SUBJECT: 25-S2-10001-03140  
Eagles Express C-Store Renovation  
Due: 5-14-24 / 2PM / Local Time

#### Addendum #1

<b>Project:</b>	Eagle Express Convenience Store Renovation 7700 Mahrenholz Rd Evansville, IN 47712	<b>Addendum No.:</b>	001
		<b>Date:</b>	April 26, 2024
<b>Owner:</b>	University of Southern Indiana 8600 University Blvd Evansville, IN 47712	<b>Project Number:</b>	2312-357
		<b>Contract for:</b>	All Construction

**DEMOLITION PLAN & FLOOR PLAN**

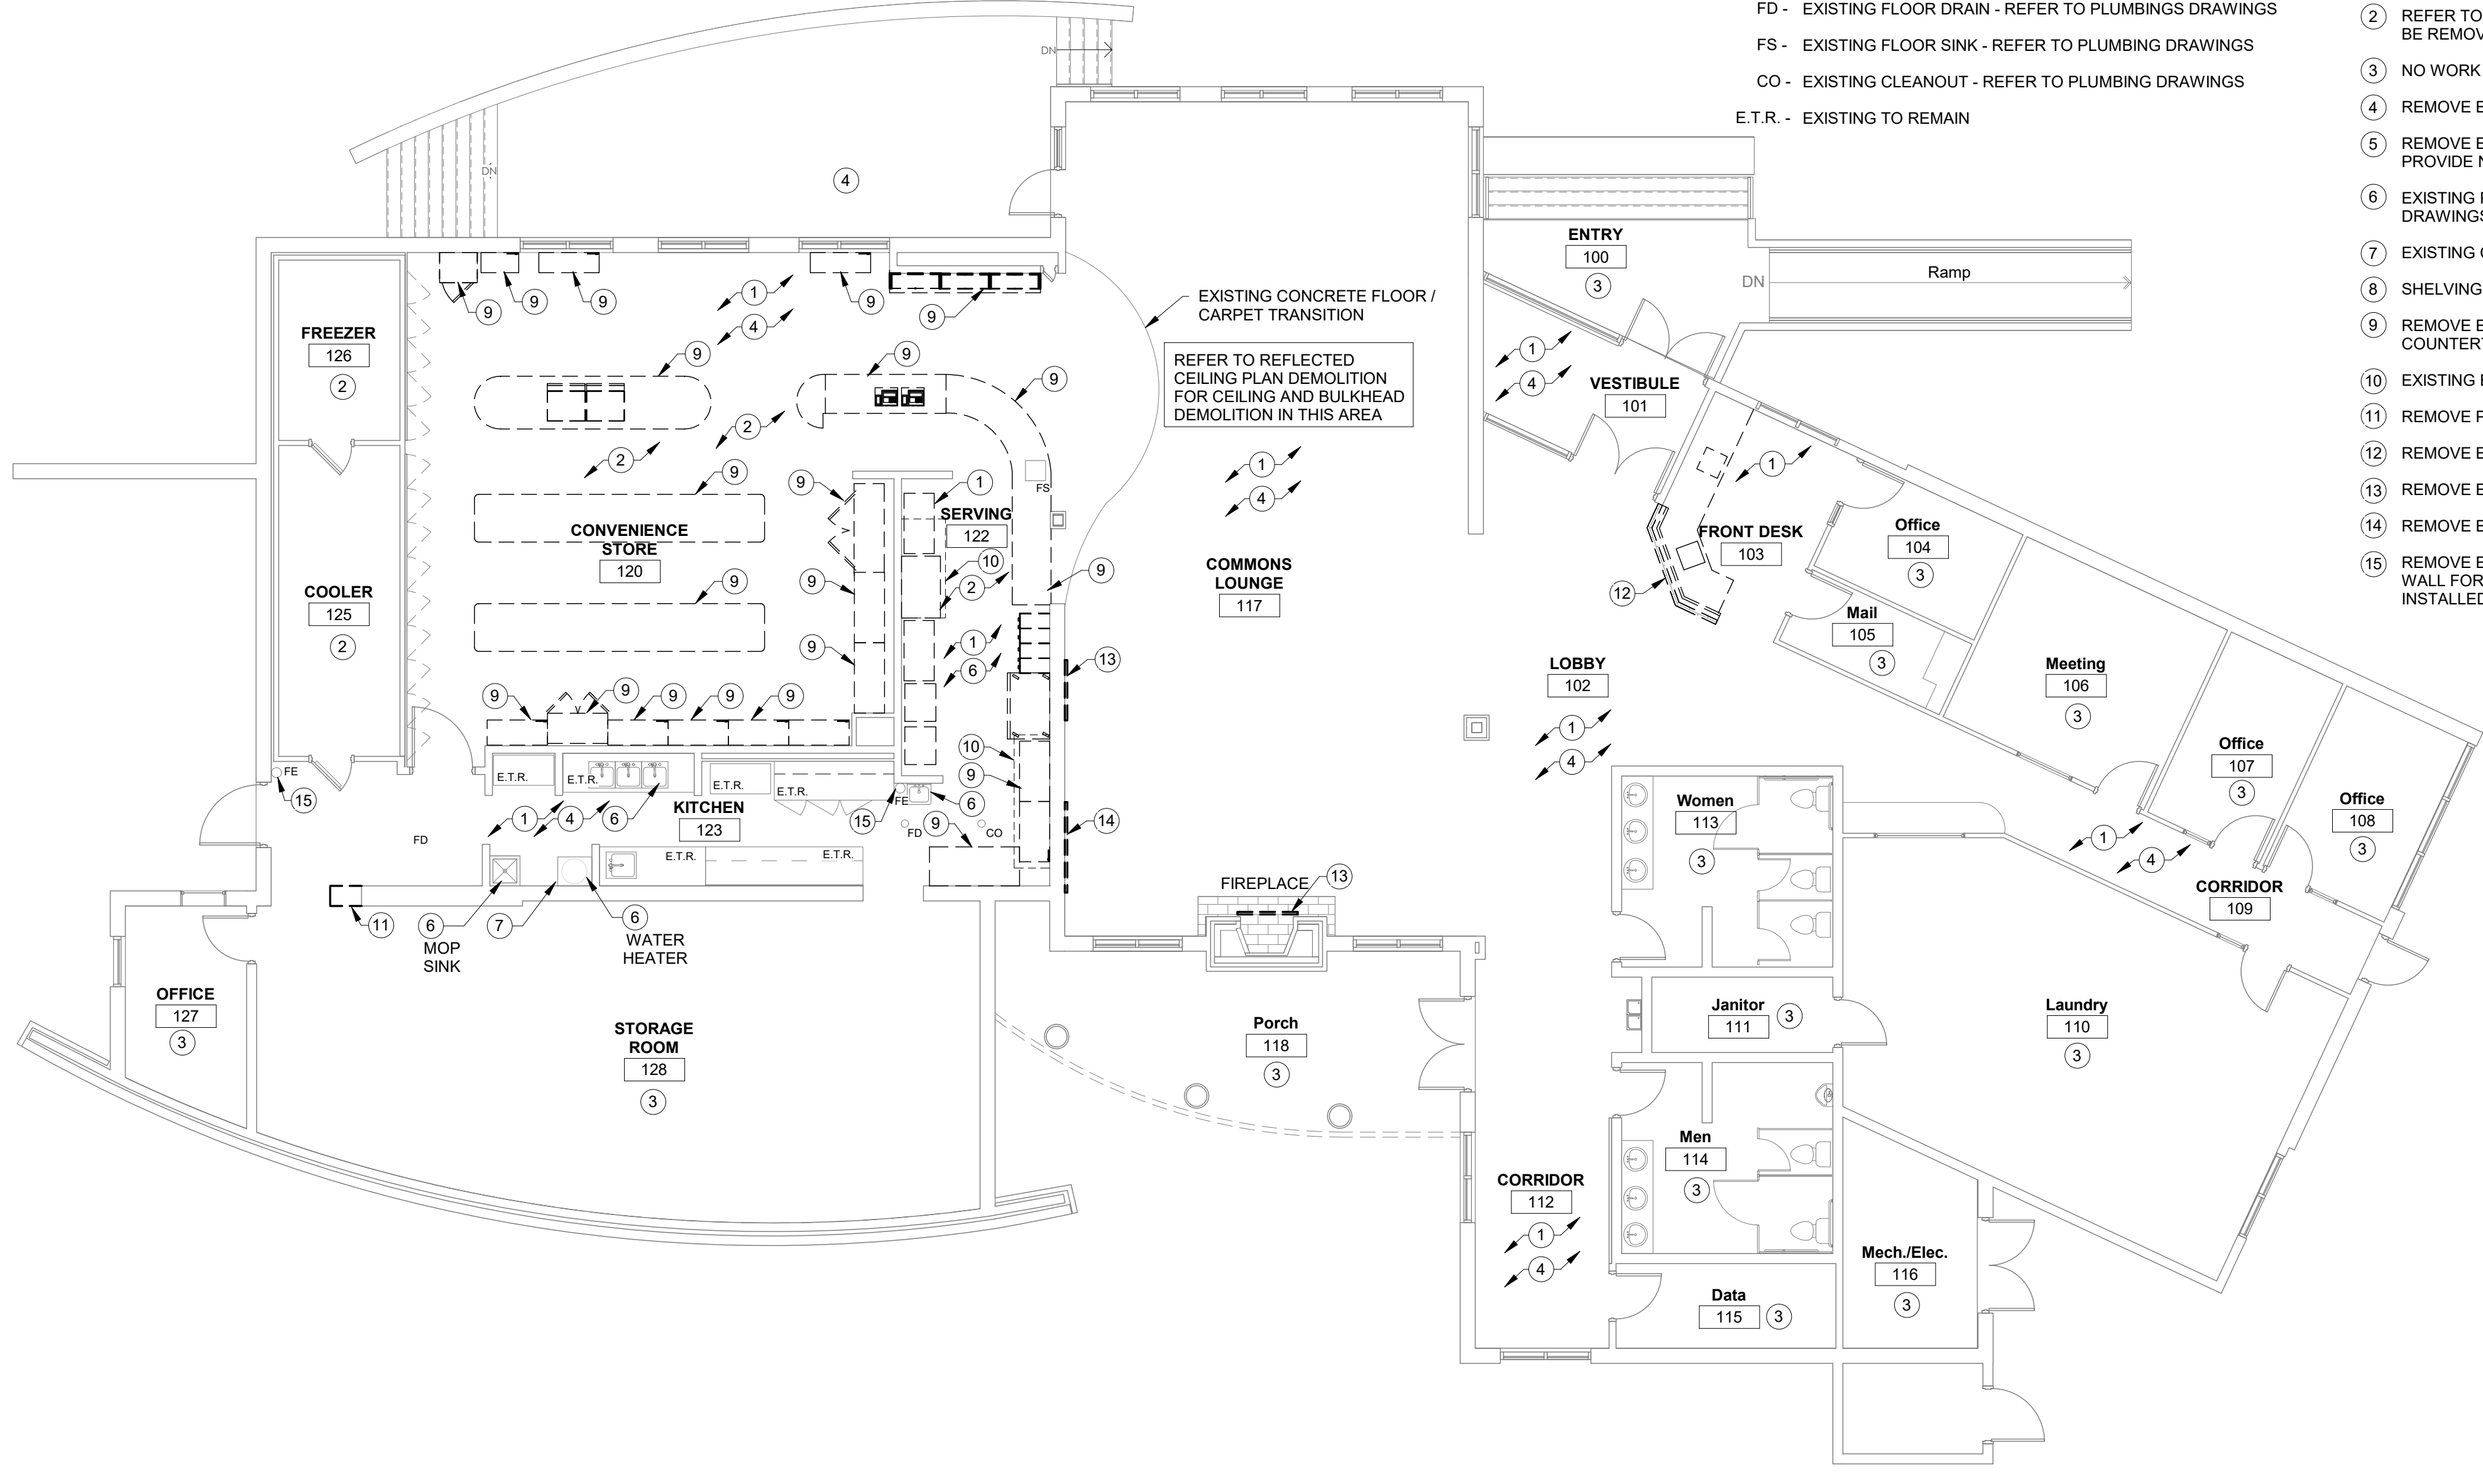
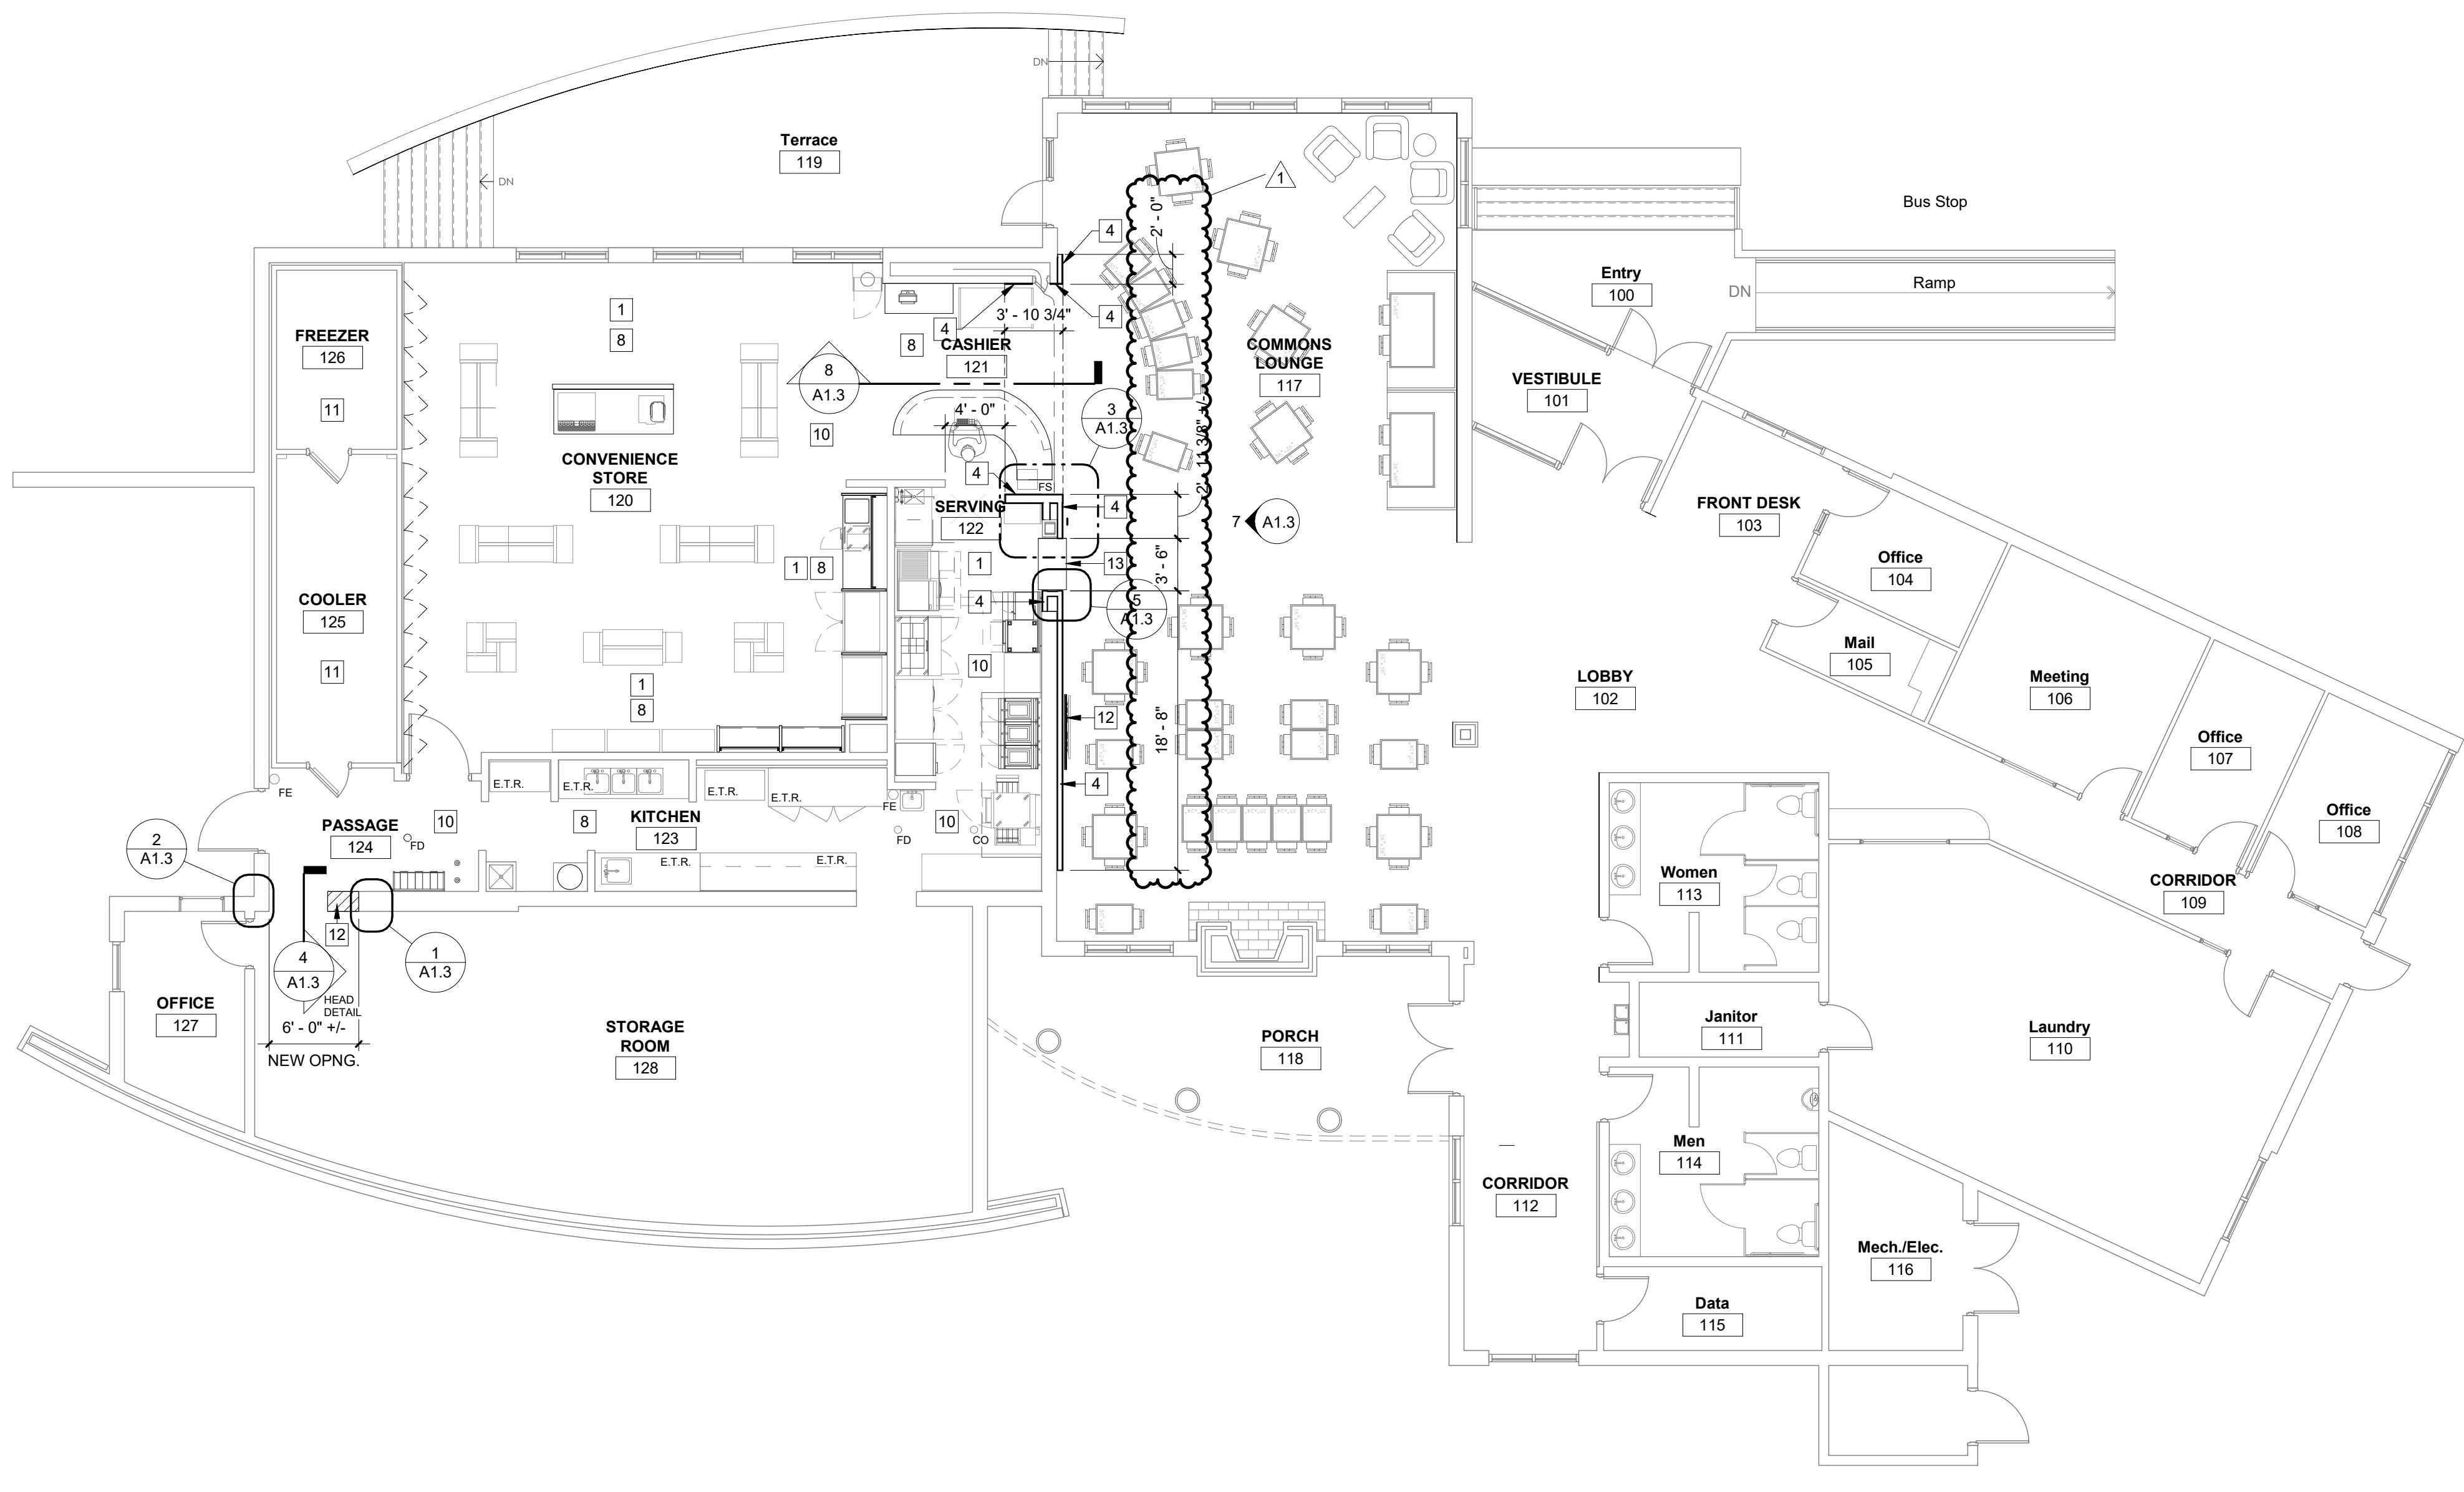
- 1-4 Drawing A1.1 Demolition Plan & Floor Plan:
  - A. This Drawing is being reissued to revise notes as shown.
- 1-5 Drawing A1.2 Reflected Ceiling Plan:
  - A. This Drawing is being reissued to revise notes as shown.
- 1-6 Drawing A1.3 Roof Plan & Details:
  - A. Details 3 & 6/A1.3 and Interior Elevation 8/A1.3 has been revised to better represent required conditions.
- 1-6 Drawing E3.1 Lighting Plan
  - A. This drawing is being reissued to revise missing fixture tags.
- 1-7 Drawing M2.1 HVAC Details and Schedules, Rooftop Unit Schedule
  - A. Revised model number for RTU-1.
  - B. Provide roof curb adaptor as required for all units.
